Los Angeles Regional Water Quality Control Board

SUBJECT: REVIEW OF SOURCE CONTROL PILOT STUDY WORK PLAN AND AMENDMENT TO CLEANUP AND ABATEMENT ORDER NO. R4-2021-0079, PURSUANT TO CALIFORNIA WATER CODE SECTION 13304

SITE: SKYPARK COMMERCIAL PROPERTIES (ASSESSOR PARCEL NO. 7377-006-906), 24701 – 24777 CRENSHAW BOULEVARD AND 2530, 2540, AND 2600 SKYPARK DRIVE, TORRANCE, CALIFORNIA (SCP NO. 1499)

Attachment 2 - Figure 12 – Sparging and Sampling Locations

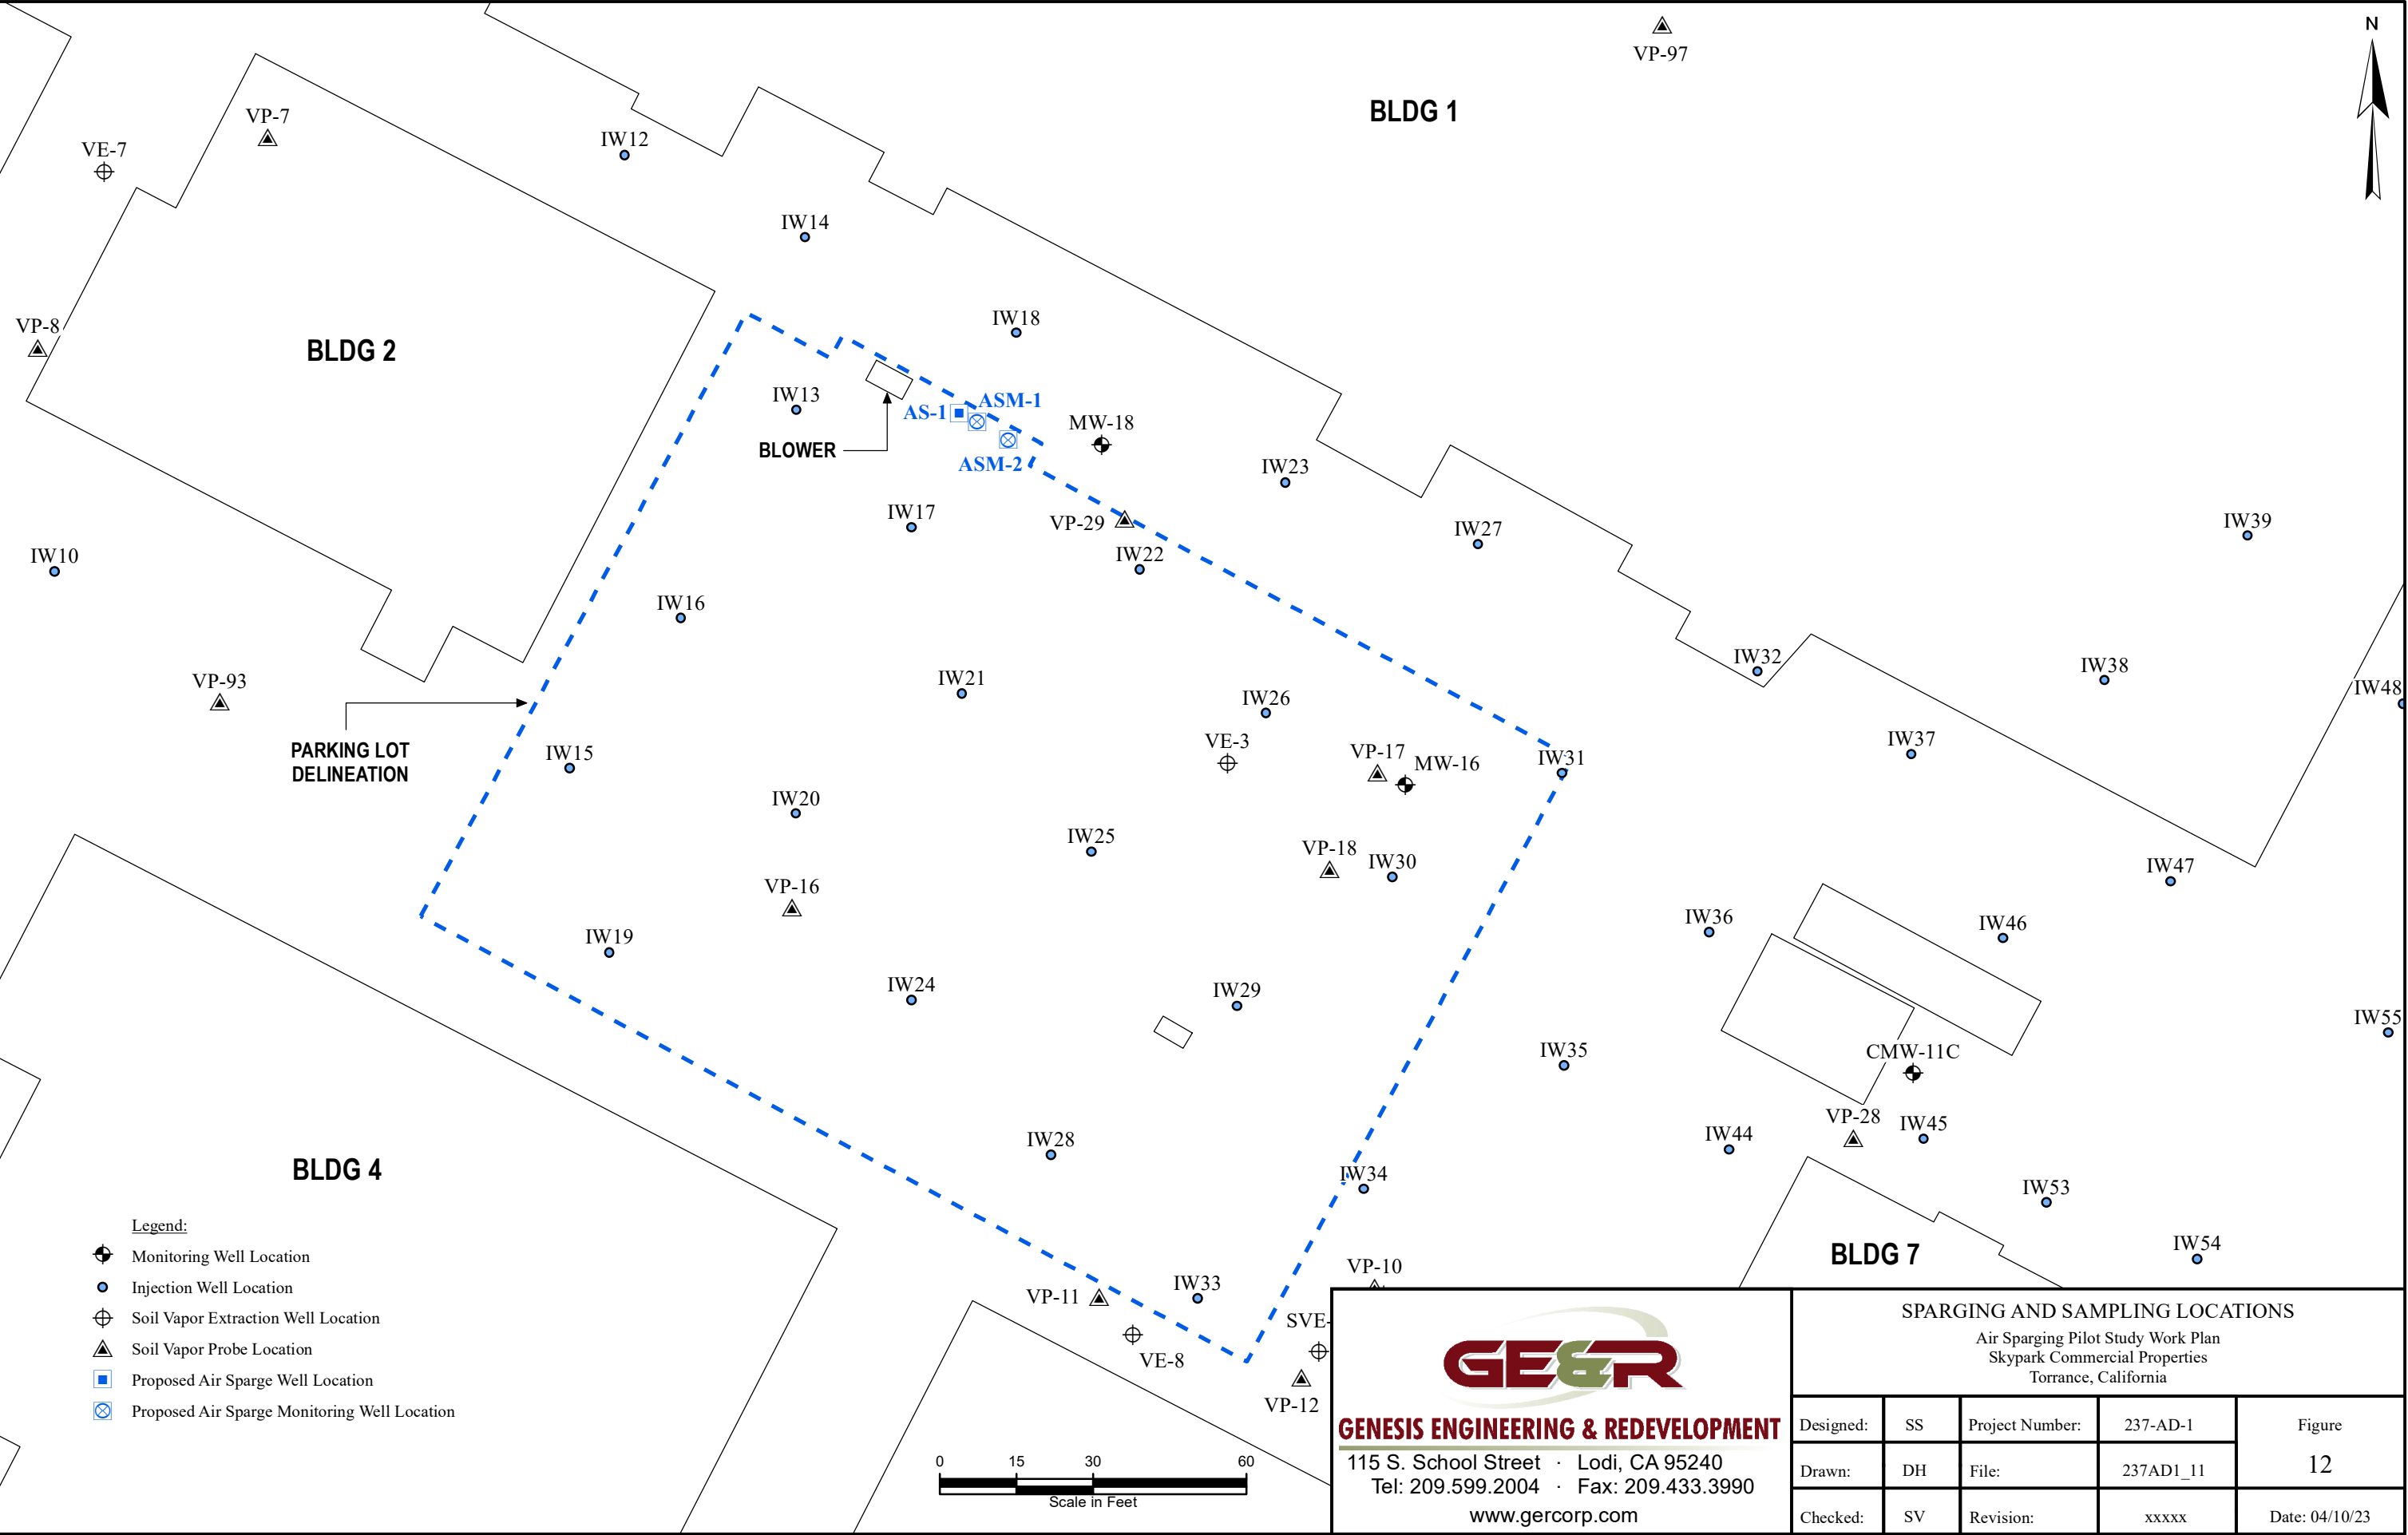
1. The effects on shallow groundwater from the implementation of the Pilot Study Work Plan are expected to be radial and emanating from AS-1. The proposed network of groundwater monitoring wells (i.e., MW-18, MW-41, ASM-1, and ASM-2) may not provide adequate resolution of the expected effects. For example, MW-41 is an intermediate monitoring well that is screened from 140 to 150 ft-bgs (screened in a different zone that is 20 feet below the screened interval of AS-1 and 27 feet below the screened interval of MW-18) and located more than 60 feet west-southwest from AS-1.

There are no proposed groundwater monitoring points to the south, west, and north of AS-1. Additionally, aside from groundwater monitoring well MW-18 (the most recently available shallow groundwater concentration high at the HSC property and the general basis for the location of AS-1), there are no groundwater monitoring points eastward.

- a. Dual-nested injection wells IW-13, IW-14, IW-17, IW-18, IW-22, and IW-23 (all of which have screened intervals at 88 to 98 ft-bgs [shallow] and 103 to 113 ft-bgs [deep]) should be repurposed as groundwater monitoring points and incorporated into the implementation of the Pilot Study Work Plan (e.g., step-testing, step test monitoring, extended operation, extended operation monitoring, etc).

2. Similarly, the effects on soil vapor are expected to be radial and emanating from AS-1; therefore, at least two additional multi-nested soil vapor probes must be installed within the area of influence of AS-1 as the closest soil vapor probe, VP-29, is more than 36 feet away from AS-1. The probes must be constructed similarly to VP-29 (i.e., probes at 5, 15, 25, 45, 65 and 85 ft-bgs). These probes must be included in the proposed activities described in Summary of Pilot Study Work Plan items nos. 4.c. and 4.d. (i.e., negative pressure measurements and VOCs analyses across all depths).

3. A tracer test (i.e., helium tracer test) should be included in the implementation of the Pilot Study Work Plan. The tracer gas will offer additional lines of evidence/confirmation of the lateral extent of the air distribution (and capture zone of the SVE system) and may discern preferential flow paths. The data from the tracer test component may facilitate and/or optimize future larger-scale remedial designs, if the technology is proven to be viable. The tracer test should be incorporated as part of the Pilot Study Work Plan.

4. A minimum of one additional SVE well should be installed in the immediate vicinity of AS-1 (i.e., within/less than the expected ROI of 20 to 30 feet). The current closest SVE well to AS-1 is VE-3, which is more than 80 feet away. The additional SVE well(s) should be multi-nested and capable of extracting vapors from all depths of the vadose zone; it should be constructed similarly to triple-nested SVE wells VE-6, VE-8, and SVE-13 with screened interval(s) beginning as shallow as 5 ft-bgs. The additional SVE well(s) should be incorporated with the proposed activities for VE-3 and VE-7 (i.e., wellhead vapor samples at all depths).

- i. The six dual-nested injection wells should be located and inspected. If they are deemed to be in poor working or nonworking conditions during inspection, they should be rehabilitated or replaced with new wells of similar construction and configuration (i.e., 2-inch diameter Schedule 80 PVC casing with 0.020-inch slotted screens).

- ii. The incorporation of the six dual-nested injection wells should not be in lieu of the proposed groundwater monitoring network of ASM-1, ASM-2, MW-18, and MW-41 for the Pilot Study Work Plan.

Attachment 3 - Figure 10 – Current SVE System Layout

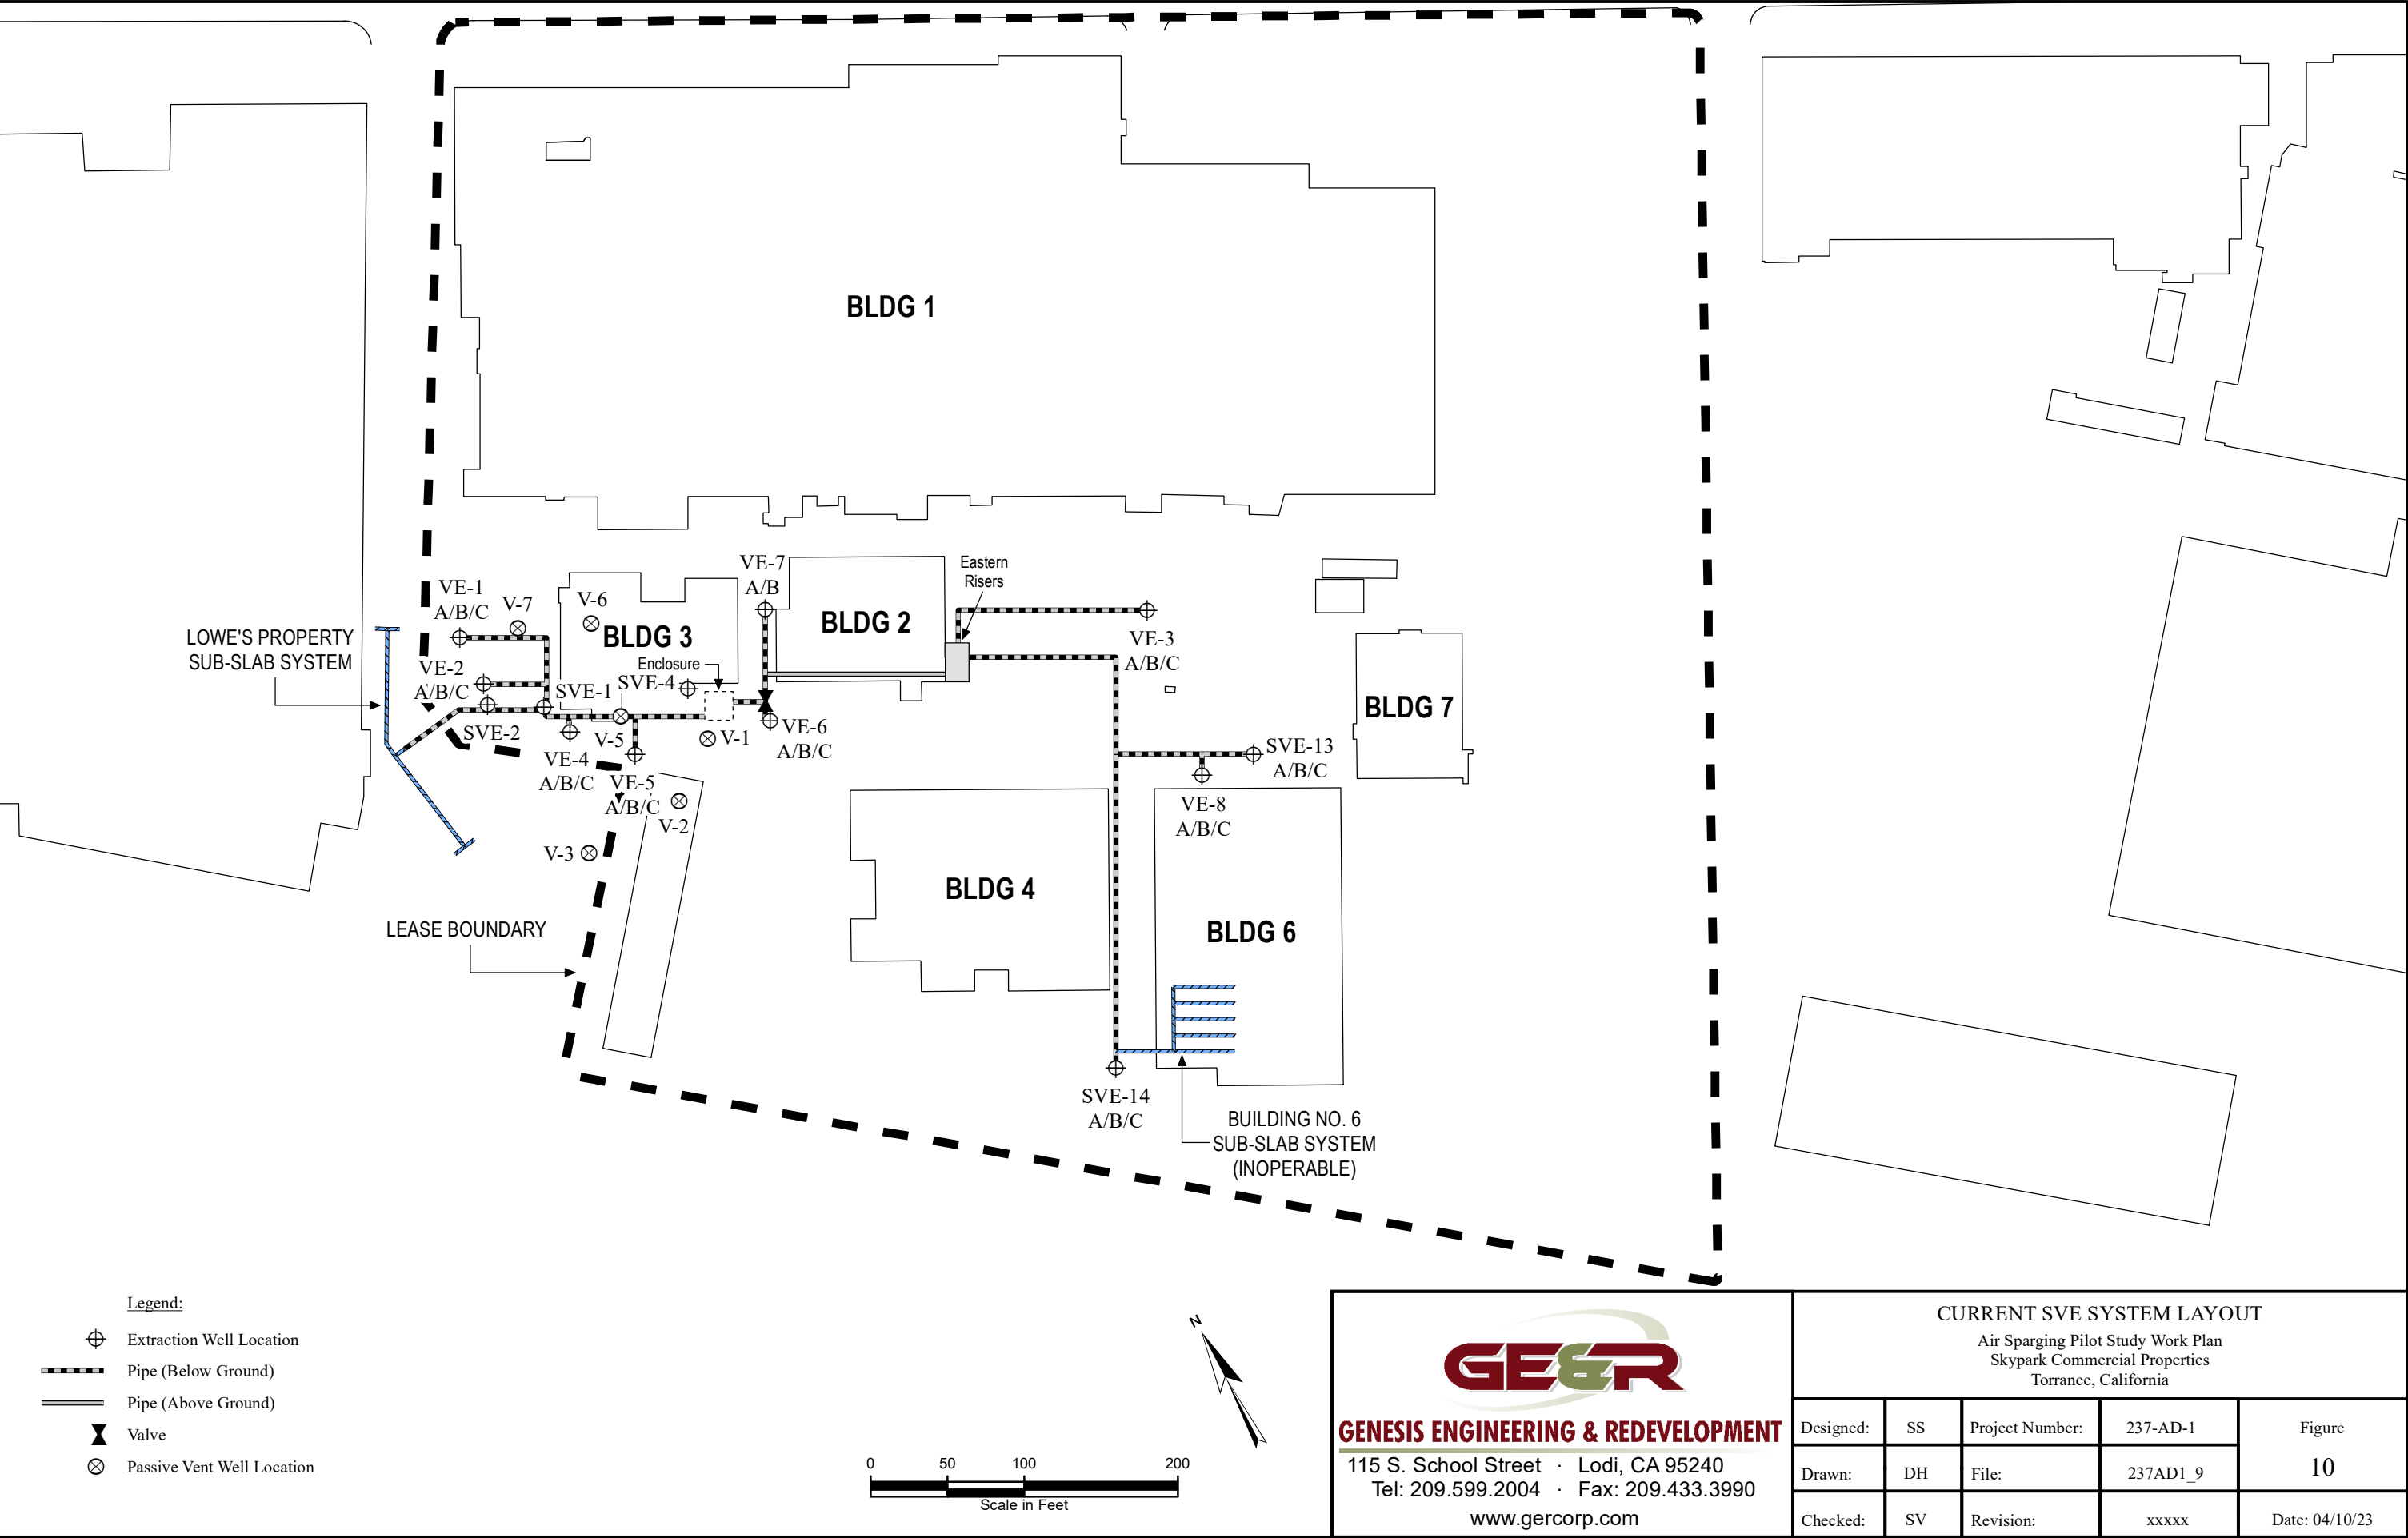
5. Due to concerns about potentially increased vapor intrusion risks during air injection, the SVE system should be continuously extracting from shallow SVE wells closest to existing buildings on the HSC property during the implementation of the Pilot Study Work Plan.

6. Given the historically elevated soil vapor concentrations detected beneath the HSC property, particularly in the western portion, the SVE system should be continuously extracting from the current array of active SVE wells (as noted in the most recent *SVE System Operation – First Quarter 2023 Report*, submitted on

behalf of HSC by GER, dated July 7, 2023) during the implementation of the Pilot Study Work Plan. At a minimum, the SVE system should be extracting from triple-nested SVE wells VE-1, VE-2, VE-4, VE-5, SVE-14, and continually toggled and optimized to prioritize mass removal to address soil vapor hot spots and contain the soil vapor plume at the HSC property during the pilot study.
